DELEGATED APPLICATION REPORT

Address: Former Woodley Arms Public House, Waldeck Street, Reading, RG1 2RF

Application No: PL/24/0993

Proposal: Non-material amendments to permission 171893 (erection of two buildings to accommodate 38 student units, as allowed on appeal on 10/10/2018) to alter the wording of condition 2 (approved plans) to provide various changes to Block 1 (all sought retrospectively), including replacing render with composite cladding, window alterations and inclusion of guttering, downpipes & vents on all elevations, an altered roof form on the north elevation, an altered entrance and replacement of brickwork with cladding on the south elevation, together with various other associated alterations (amended description).

ii. North elevation

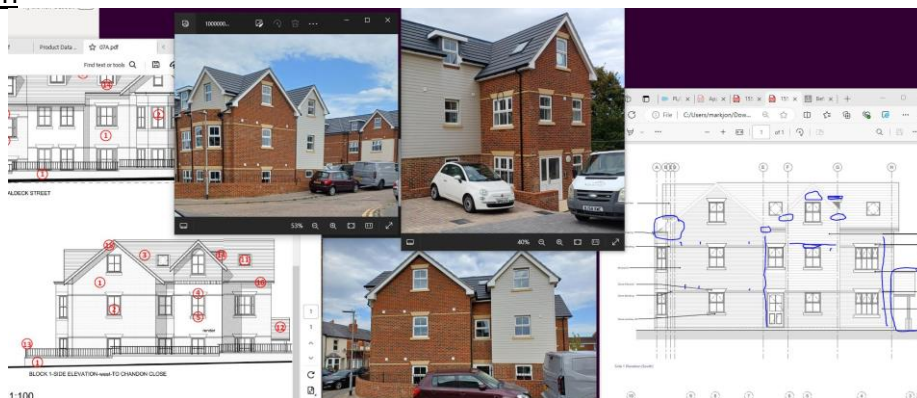
- The windows on the gabled elevations are wider and aligned slightly differently to those shown at the time of 221305/APPCON
- The gables in the context of the roofscape are drawn differently on the two sets of plans - the size/extent of them at these points appears to be another change.

- The extent of cladding at the bottom-most tips of the gables are not shown accurately on the plans.
- The finish on top of the dormer windows are significantly 'chunkier' when viewed on site in comparison to how they appear on the plans submitted.

- The transition in the roof ridge is different when comparing the two sets of plans (straight line versus 45 degree line. This is a further change proposed to be incorporated as part of this application.

- The guttering/downpipes and the various unsightly vents (as seen on site) have not been specified on the plans – they should be added onto the plans.

- Where the cladding is now provided, this results in the windows no longer including the window heads above them, as shown on the previously approved plans.

- On the second bay the extent of brickwork above the first floor window appears greater in height in the proposal / on-site, in comparison with that shown at the time of 221305/APPCON.

vi. The agent subsequently replied advising that further measurements would be undertaken on site, in order to update the plans accordingly. These revised elevation plans were submitted on 21/10/2024 and showed all of the changes referenced in feedback summarised above being incorporated into the proposals.

iii. West elevation

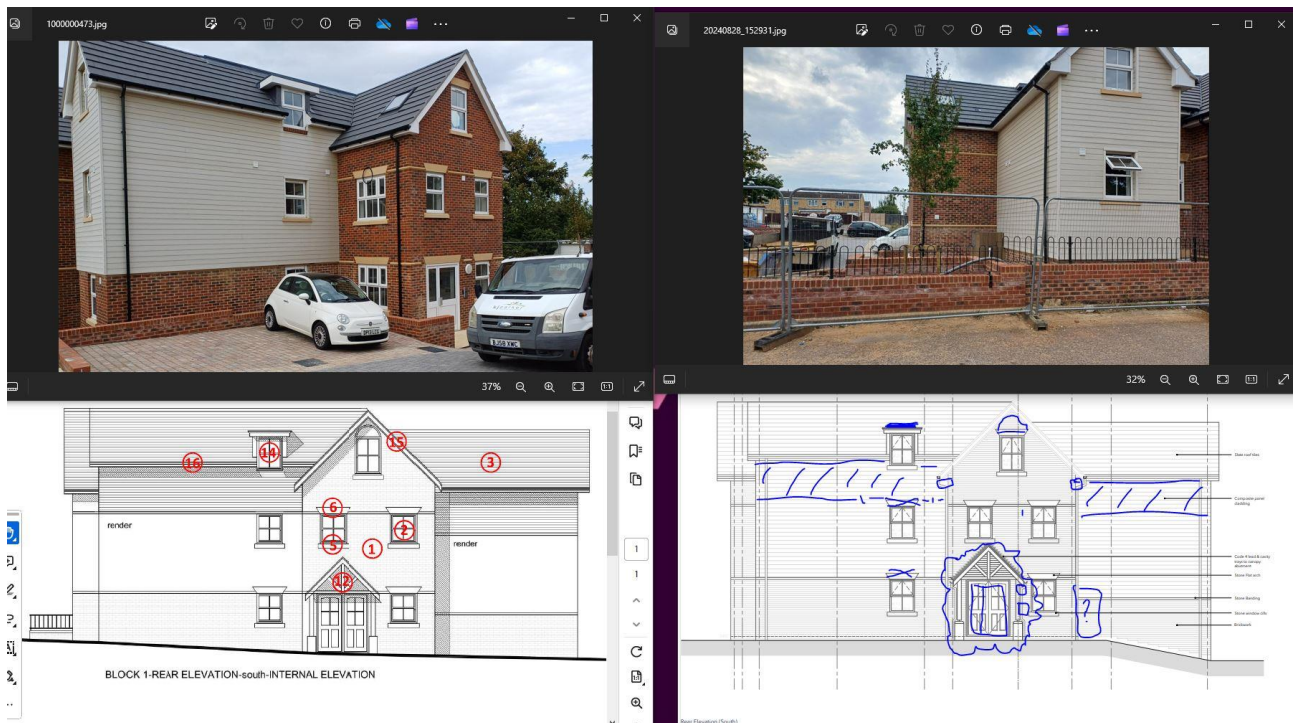
- The relationship on the bottom corner of the gable on the north-western edge of the site is not shown accurately on the plan submitted, with the cladding evident in part (although partly hidden by guttering and the roof).
- The design of the 2nd floor window on the part of the elevation where cladding is now provided has changed, with the omission of the curved feature and inclusion of a window which matches others on the building being built instead.
- The guttering/downpipes and the various unsightly vents (as seen on site) have not been specified on the plans – they should be added onto the plans.
- The extent of the fascia and soffits at the base of the gables appear greater in extent than shown on either the approved or now proposed plans.
- The entrance canopy on the southern elevation has not been included. It is unclear whether this is no longer proposed, or still to be built.

iv. South elevation

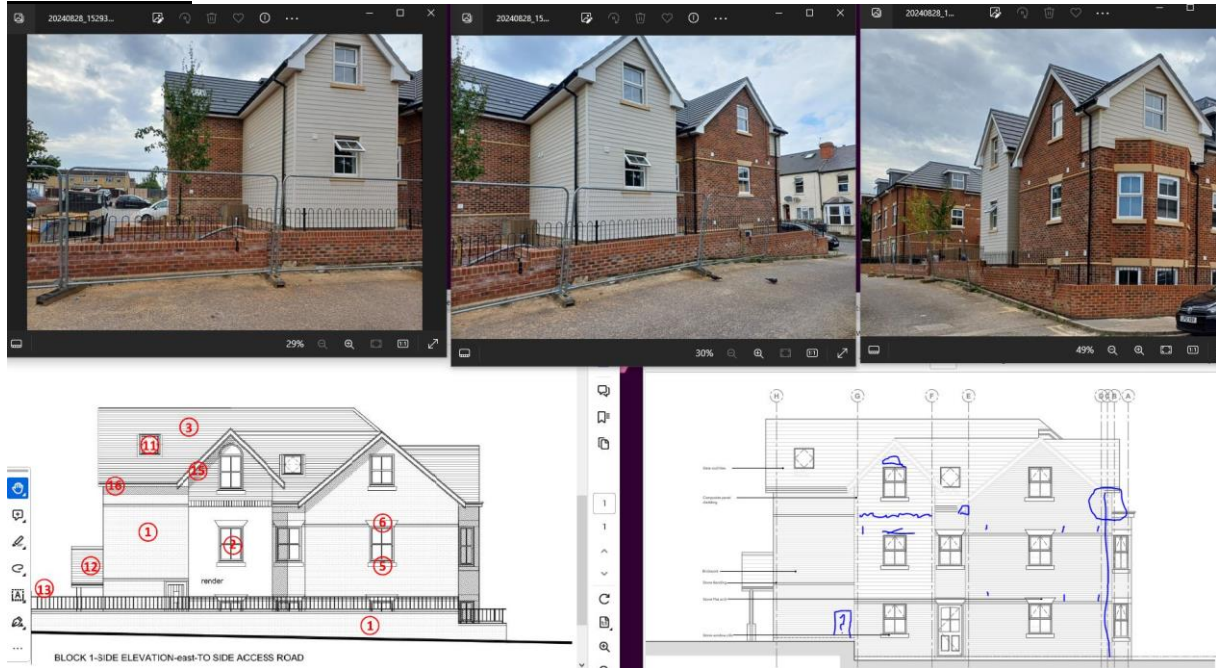
- The proposals appear to not only provide cladding instead of render, but replace areas of approved brickwork (above the first floor windows) with cladding too.

- The entrance canopy on the southern elevation has not been included. It is unclear whether this is no longer proposed, or still to be built.
- A light and intercom system has been installed adjacent to the proposed entrance, but are not shown on the plans.

- The door design for the entrance differs from that shown on the previously approved / now proposed plan (only a single opening door has been installed).

- The various unsightly vents (as seen on site) have not been specified on the plans – they should be added onto the plans.
- The design of the centrally positioned 2nd floor window has changed, with the omission of the curved feature and inclusion of a window which matches others on the building being built instead.

- The extent of the fascia and soffits at the base of the gables appear greater in extent than shown on either the approved or now proposed plans.
- The inclusion of cladding results in the approved window heads and banding no longer being proposed.

- The finish on top of the dormer window is significantly 'chunkier' when viewed on site in comparison to how they appear on the plans submitted.
- Some form of structure appears to have been added to the east of the entrance.

North (Waldeck Street) elevation, as allowed on appeal (left), 221305/APP CON (middle) and as now proposed (right). Site photograph (below).

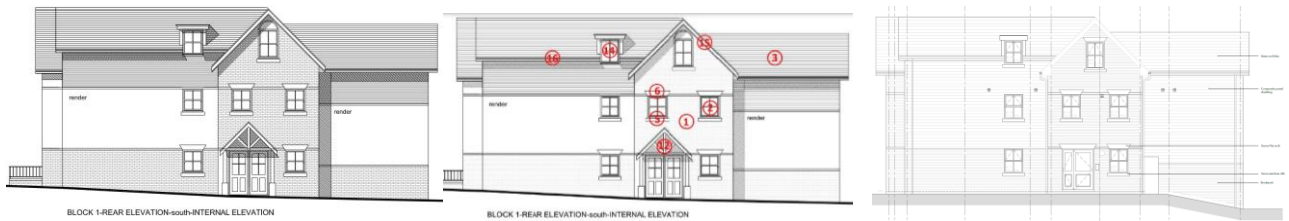
- vii. The gables on the north elevation have been built slightly bigger than on the approved plans / those at the time of the approval of details application, as shown below, with the gables built up so that the ridge line aligns with the main roof ridge point, rather than being set down as approved. The overall appearance is still of a symmetrical gable end, but ones that are more prominent than those originally permitted. In addition, a comparison of the elevation plans reveals that the position of two of the three dormers on this roofslope have been built at lower points of the roofslope than permitted, with the removal of a gap between the roof material and the brickwork of the main face of the building being particularly unfortunate. Whilst there are considered to be regrettable changes, they are not considered to be so harmful in themselves, either individually or cumulatively, to resist this application on this basis, with the appearance of the roofscape witnessed on site (see photograph below) being considered to be adequate in the context of the original permission.
